**Work Order ID 104376****\*104376\***

Item Name: Fwd Crosstube

DRAWING NO. D407-667-145	TITLE CROSSTUBE ASS'Y (407 HIGH FWD)	REV. C	DART AEROSPACE LTD ENGINEERING ORDER		D.E.O. NO. D407-667-145-C-1	SHEET NO. SHEET 1 OF 1	SCALE NTS
DRAWN 90	CHECKED ASS	MFG. APPR. 18	APPROVED WD		DE APPR. H		
DATE 11.07.15	DATE 11.07.22	DATE 11.07.22	DATE 11/07/22		DATE 11.07.21

DRAWING NO. D407-667-145	TITLE CROSSTUBE ASS'Y (407 HIGH FWD)	REV. C	DART AEROSPACE LTD ENGINEERING ORDER		D.E.O. NO. D407-667-145-C-2	SHEET NO. SHEET 1 OF 1	SCALE NTS
DRAWN AJS	CHECKED	MFG. APPR.	APPROVED		DE APPR.		
DATE 12.08.02	DATE 12.08.02	DATE 12.08.02	DATE 12.08.02		DATE 12.08.02

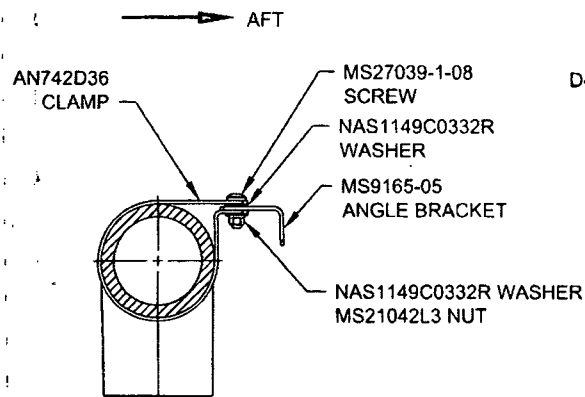
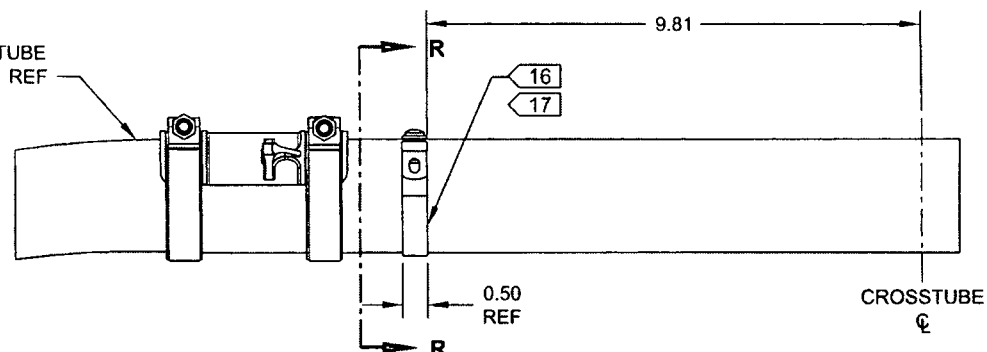
ADD ELECTRICAL GROUNDING STRAP

ITEM	QTY -145	PART NUMBER	DESCRIPTION
1	X	D407-667-145	CROSSTUBE ASSEMBLY (407 HIGH FWD)
⚡			
10	2	AN742D36	CLAMP
11	2	MS9165-05	ANGLE BRACKET
12	2	MS21042L3	NUT (OR MS21042-3)
13	2	MS27039-1-08	SCREW
14	4	NAS1149C0332R	WASHER (OR AN960C10L)

**DETAIL P**  
BONDING STRAP INSTALLATION 2 PL
